**SUBDIVISION &
PLANNED UNIT DEVELOPMENT
STAFF REPORT**

Date: September 15, 2022

<u>DEVELOPMENT NAME</u>	Duplantis Design Group, PC
<u>SUBDIVISION NAME</u>	Brewer Center Subdivision, Resubdivision of Lot 3A
<u>LOCATION</u>	975 Schillinger Road South (Northeast corner of Schillinger Road South and Hitt Road).
<u>CITY COUNCIL DISTRICT</u>	District 6
<u>AREA OF PROPERTY</u>	3 Lots / 8.5± Acres (Subdivision) 8 Lots / 39.4± Acres (PUD)
<u>CONTEMPLATED USE</u>	Subdivision approval to create three (3) legal lots of record from a single legal lot of record; and Planned Unit Development approval to amend a previously approved Planned Unit Development to allow shared access between multiple building sites.
<u>TIME SCHEDULE FOR DEVELOPMENT</u>	Not provided

SITE PLAN

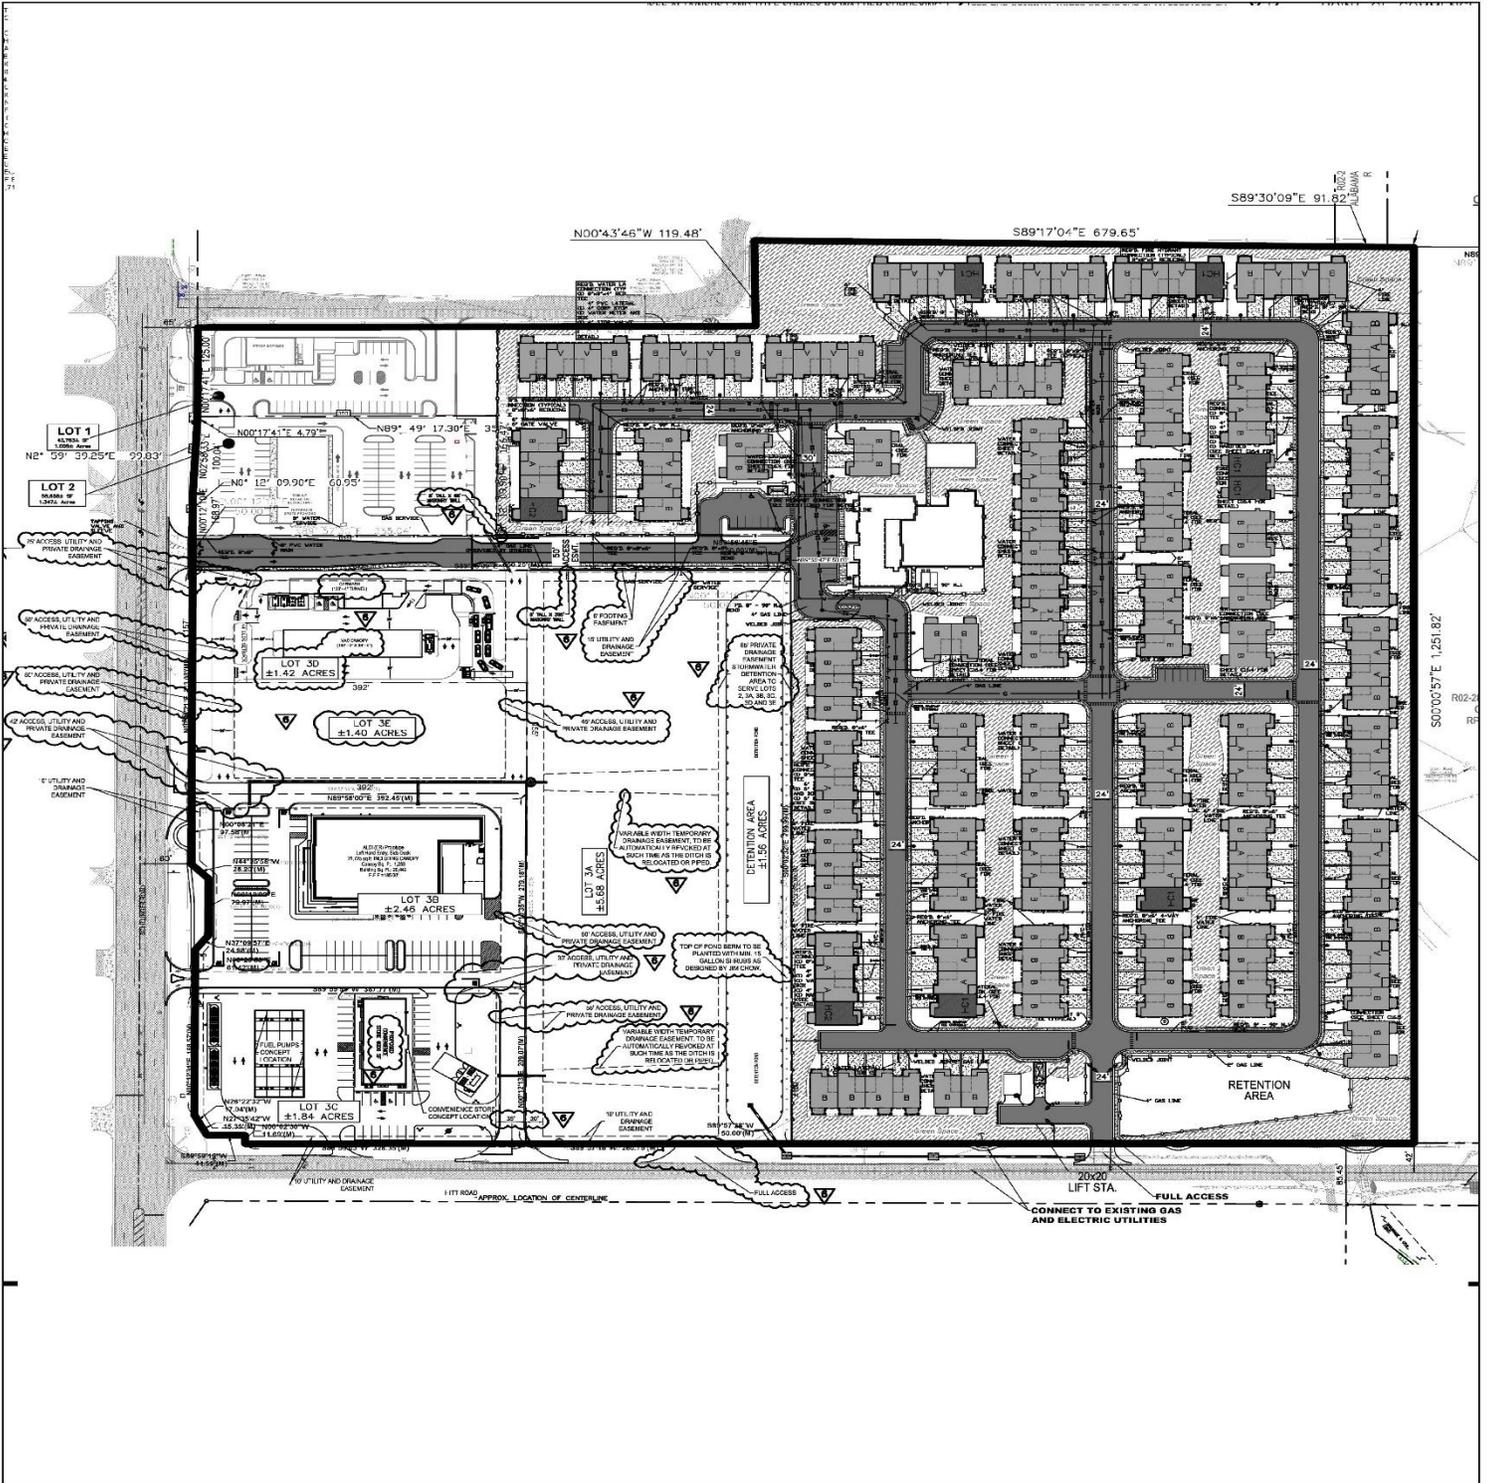
The site plan submitted for the PUD depicts proposed Lot 3E and Remainder Lot 3A as remaining undeveloped at this time, with a proposed car wash shown on proposed Lot 3D, and a proposed convenience store with fuel pumps on the existing Lot 3C.

The proposed car wash on Lot 3D includes a car wash tunnel, vacuum canopy, and payment kiosks. If approved, the site plan should be revised to provide the total square footage of the car wash tunnel as well as the number of vacuum bays under the canopy. Furthermore, either a dumpster

The proposed convenience store on Lot 3C is 6,000 square feet, which requires a total of 20 parking spaces. As 36 parking spaces are proposed to be provided, a photometric site plan should be submitted at the time of permitting. A dumpster is depicted on the site plan, but does not include information about the dumpster enclosure or sanitary sewer connection. If approved, a note should be added to the site plan stating that a compliant enclosure and sanitary sewer connection will be provided.

- 4) Placement of a note stating that no structures are allowed in any easements without the easement holder’s permission;
- 5) either depiction of a dumpster with compliant enclosure and sanitary sewer connections, or a note placed on the site plan stating that curbside pickup will be utilized for Lots 3D and 3C;

DETAIL SITE PLAN

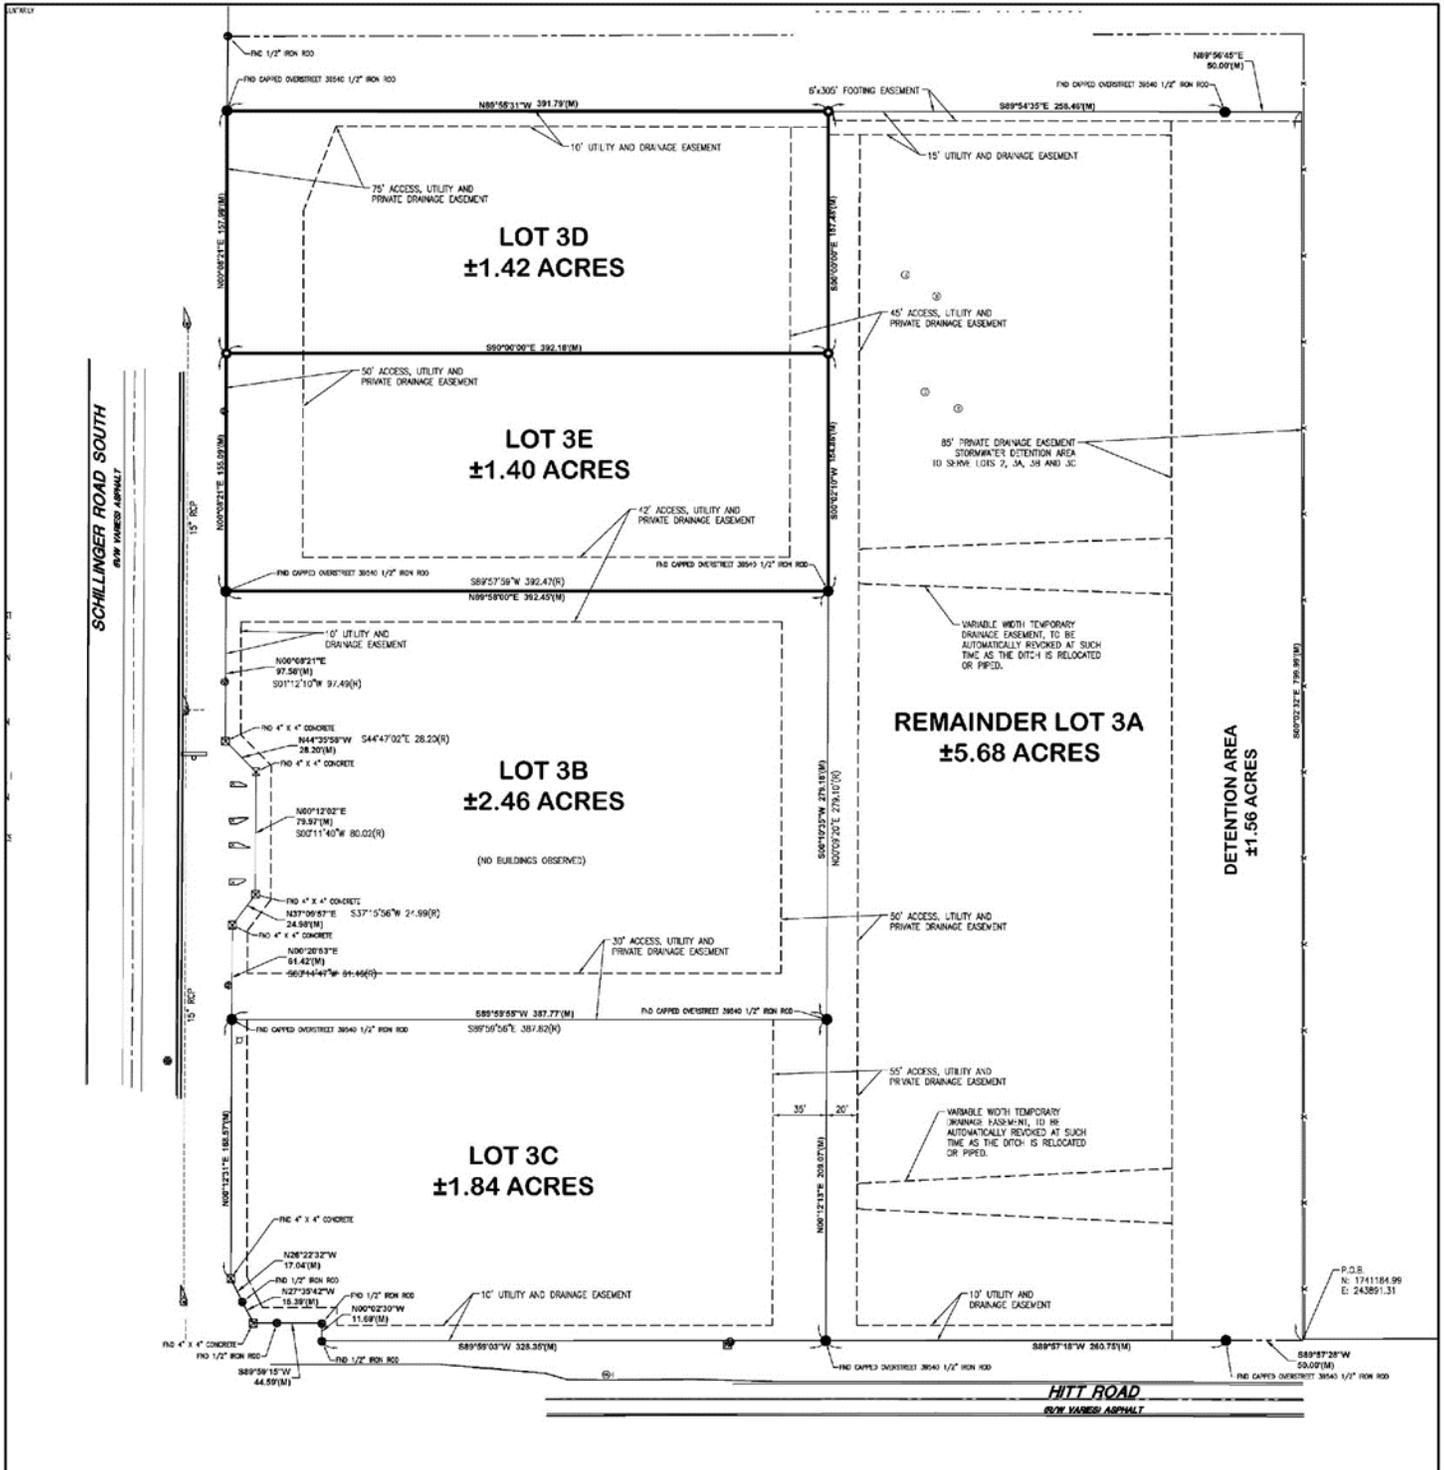
The preliminary plat does not indicate the 25' minimum building setback line for either street. If approved, the setback should be illustrated and labeled on the Final Plat.

As depicted on the preliminary plat, the proposed lots are called, "Lot 3D", "Lot 3E", and "Remainder Lot 3A". If approved, these should be relabeled as "Lot 3A", "Lot 3D", and "Lot 3E".

- 1) Provision of the lot sizes in square feet and acres on the site plan, or provision of a table with the same information;
- 2) Renaming the proposed lots as “Lot 3A”, “Lot 3D”, and “Lot 3E”;

- 3) Revision of the plat to illustrate the 25-foot minimum building setback line along all street frontages, per Section V.D.9. of the Subdivision Regulations;
